UNITED STATES  
NUCLEAR REGULATORY COMMISSION  
WASHINGTON, D.C. 20555-0001

SAFETY EVALUATION BY THE OFFICE OF NUCLEAR REACTOR REGULATION  
RELATED TO AMENDMENT NO. 77 TO FACILITY OPERATING LICENSE NO. NPF-37,  
AMENDMENT NO. 77 TO FACILITY OPERATING LICENSE NO. NPF-66,  
AMENDMENT NO. 69 TO FACILITY OPERATING LICENSE NO. NPF-72,  
AND AMENDMENT NO. 69 TO FACILITY OPERATING LICENSE NO. NPF-77  
COMMONWEALTH EDISON COMPANY  
BYRON STATION, UNITS 1 AND 2  
BRAIDWOOD STATION, UNITS 1 AND 2  
DOCKET NOS. STN 50-454, STN 50-455, STN 50-456 AND STN 50-457

Figure 1

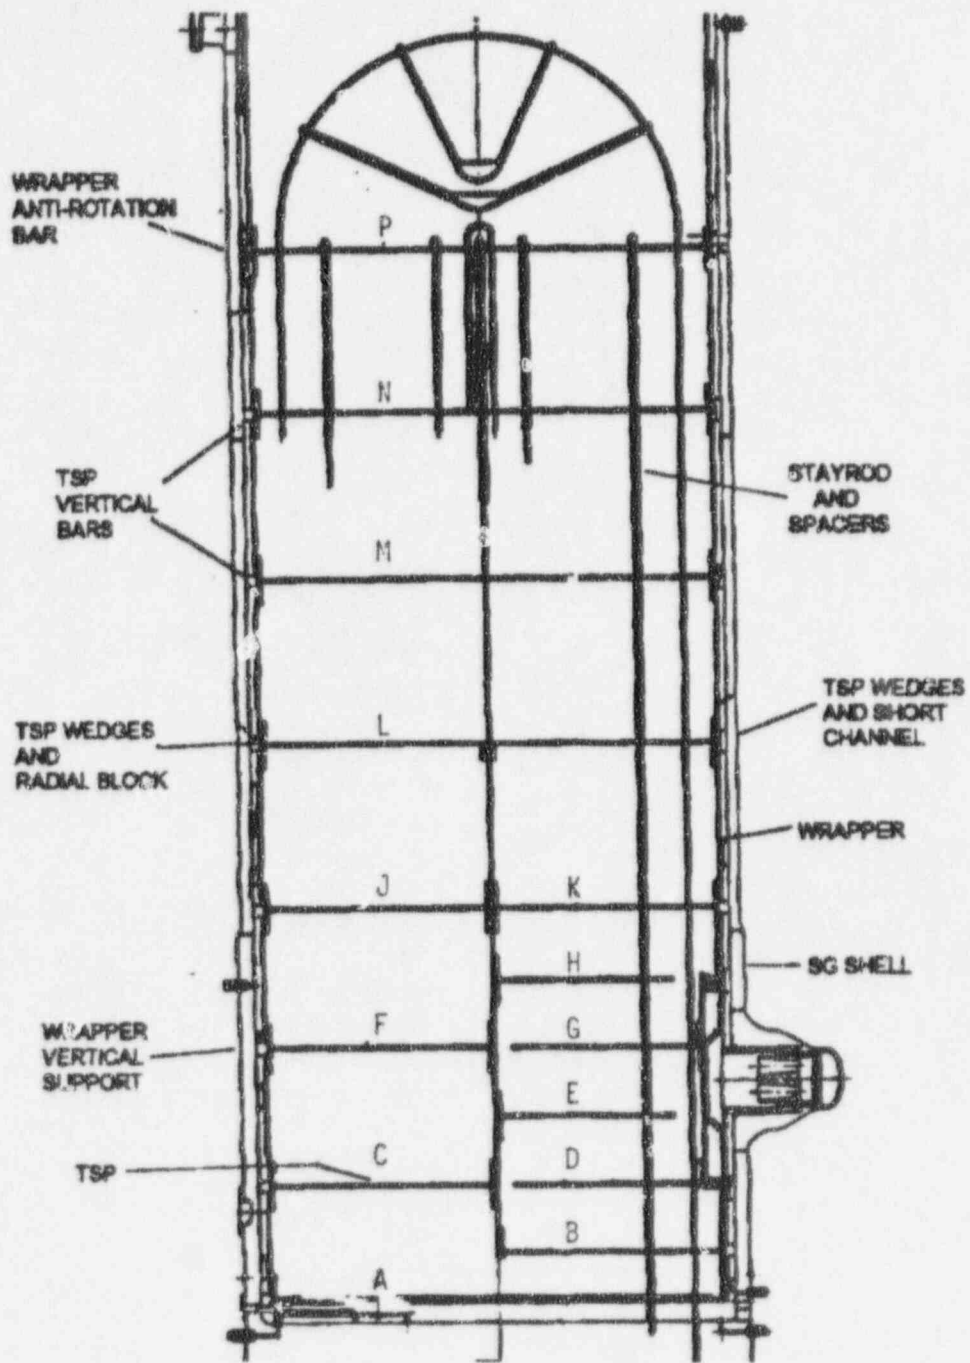
The various TSPs and baffle plates are supported vertically within the SG using several support mechanisms. A schematic of the tube bundle region is shown in Figure 1, with each of the various plates identified. Westinghouse uses letter designations to identify the baffle plates at various elevations with 'A' representing the FDB and 'B,' 'D,' 'E,' 'G,' and 'H,' representing preheater baffle plates which have no circular holes. On the hot-leg side, two semi-circular plates, 'C,' and 'F,' with SG tube holes and circulation holes, are located at the elevations of the 'D' and 'G' preheater baffle plates. Plates J and K on the hot-leg and cold-leg side at the top of the preheater have SG tube holes and circulation holes. The remainder of the TSPs 'L,' 'M,' 'N,' and 'P' are full circular TSPs with similar SG tube and circulation holes. In addition, the 'L' and 'P' TSPs contain central flow slots along the SG tube lane to enhance flow upward through the SG tube bundle. For the Braidwood, Unit 1, and Byron, Unit 1, SGs, number designations are used for the TSPs. Counting upwards from the FDB plate through the preheater to the top TSP, the correspondence with the Westinghouse letter designations are: 1H = A, 2H = B, 3H = C, 4H = E, 5H = F and G, 6H = H, 7H = J and K, 8H = L, 9H = M, 10H = N and 11H = P. All of the TSPs are supported by three tierods and spacers in each of the TSP quadrants. In addition, TSPs C (3H), F (5H), and J (7H) (the Braidwood, Unit 1, and Byron,
